# ACCESS AUDIT REPORT

## NON FORMAL EDUCATION CELL

## Accessible University of Delhi

**FEBRUARY 2009**

### APPROACH

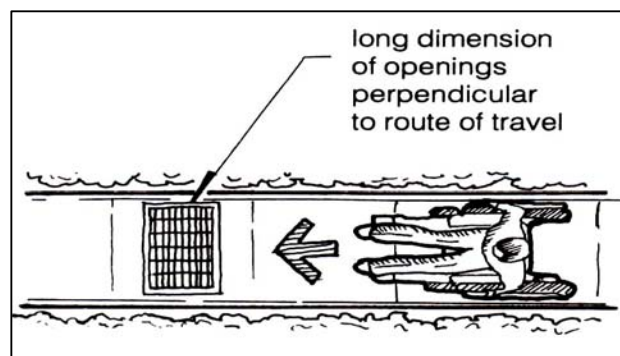
Unmaintained road trapped small wheels of the wheelchair and can also cause trip hazard for persons using mobility aids.

- ✚ Periodic general maintenance of the road should be undertaken.
- ✚ Level differences to have smooth slope/ramp.

## GENERAL PARKING

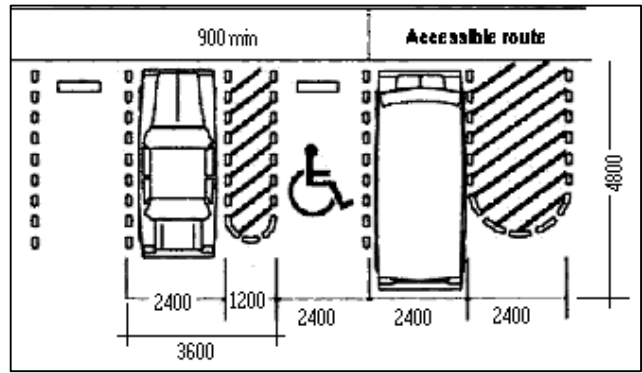
Haphazard parking obstructs right of way and safe movement of everyone particularly persons using mobility aids.

- ✚ Parking area to be clearly specified with directional signage.

### GENERAL CIRCULATION AREA

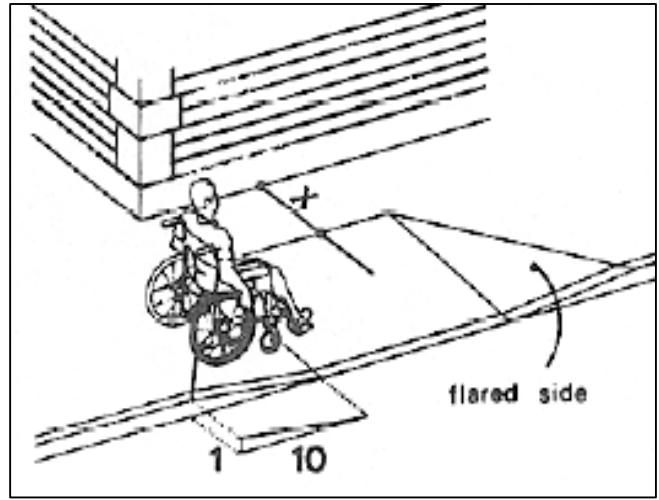
These are the main movement areas for visitors, students and staff. Protruding objects and encroachments in the line of travel restrict the movement of persons using mobility aids such as walkers, crutches etc. and hazardous for persons with low vision and vision impairment.

Pavement curb (160mm high) restricts persons using mobility aids such as walker, crutches, stick, wheelchair from accessing the service/enquiry windows and resting spaces.

- ✚ Curb ramp to be provided, as illustrated on page 7.
- ✚ Tactile guiding path (engineering configuration given at Annexure I) to be provided for the benefit of persons with vision impairment.

**Proposed signage with Braille locator**

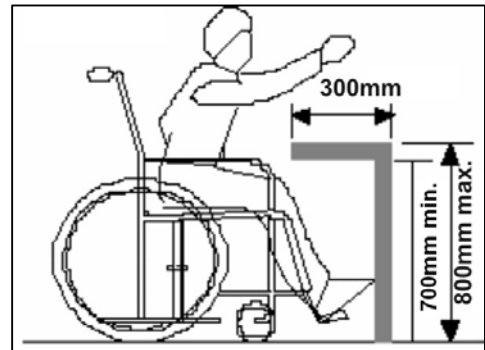
Existing counter height is 730 mm with leg clearance for wheelchair users, which is fairly accessible. Overhead shelter has been provided.

- ✚ Signage with Braille markings for enquiry counters to be placed at eye level, as per standards mentioned above.

**DRINKING WATER**

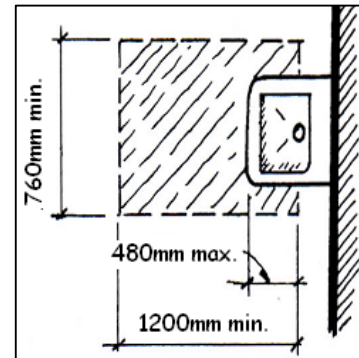
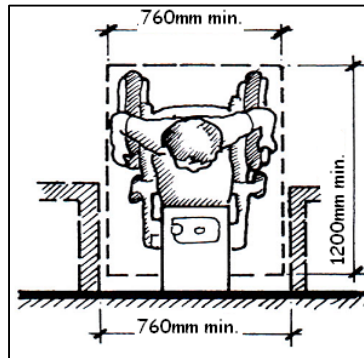
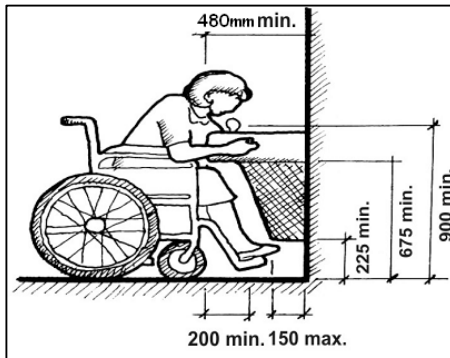
- ✚ Tap to be lowered down so that all operable parts are between 900mm-1000mm height.
- ✚ Leg and knee space to be provided (as shown in the diagrams) with basin to avoid spilling of water.
- ✚ This allows both front and parallel access to taps for students using mobility aids like wheel chair, crutches etc.

## URINALS

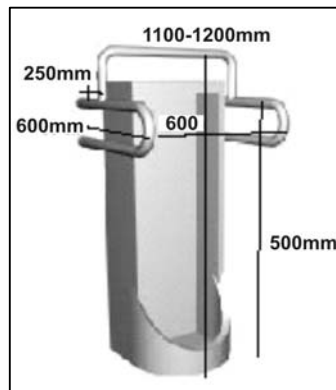
- At least one of the urinals in the **Gents toilet** should have grab bars; installed on each side and in the front of the urinal to support ambulant persons with disabilities (for example, crutch users).
- The front bar is to provide chest support; the sidebars are for the user to hold on to while standing.
- Urinals shall be stall-type or wall-hung, with an elongated rim at a maximum of 430mm above the finish floor.
- A clear floor space 760mm by 1220mm should be provided in front of urinals to allow forward approach. Urinal shields (that do not extend beyond the front edge of the urinal rim) may be provided with 735 mm clearance between them.

## ACCESSIBLE TOILET

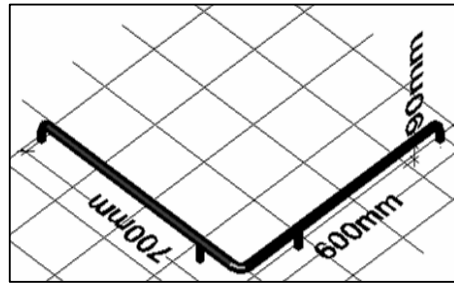
A minimum of one toilet compartment should have enough floor space for wheelchair users to enter and exit.

- Clear floor space 2000mm x 1750mm.
- Provide a door of clear opening of at least 900mm with the door swing outwards or be folding or sliding type.
- Should have slip resistant flooring.
- Accessible toilet** should have a switch near the WC (one at 300mm and the other at 900mm from the floor level), which activates an emergency audio alarm (at the reception/attendants desk, etc.).

### WASHBASIN

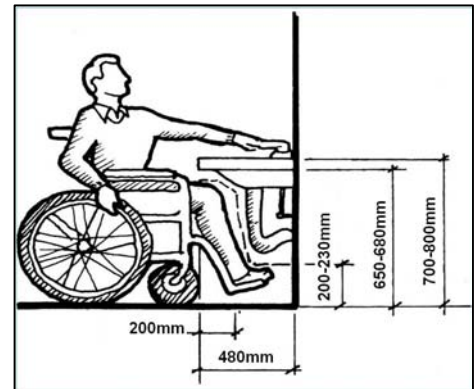
- ✚ With dimensions 520mm and 410mm, so mounted that the top edge is between 700mm-800mm from the floor; have a knee space of at least 760mm wide by 200mm deep by 650mm-680mm high.
- ✚ Lever type handles for taps are recommended.
- ✚ Mirror's bottom edge to be 900-1000mm from the floor and the mirror may be inclined at an angle.

## EMERGENCY EVACUATION

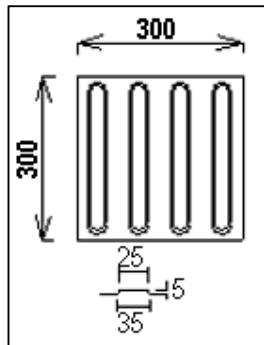
There is no Exit signage or fire hydrant observed in the building.

- ✚ **Emergency exits** should be clearly marked with proper signage and should be clear of all obstructions.
- ✚ **Emergency alarm** both audio (hooter type) and visual (flashing bulb) to be provided on each floor/level at strategic locations.
- ✚ **Employees/staff and security guards**, need to be drilled for the same at periodic intervals.
- ✚ An **access sensitization/ awareness training** to be given to security guards and staff handling/transferring students with disabilities to refuge area during emergency.
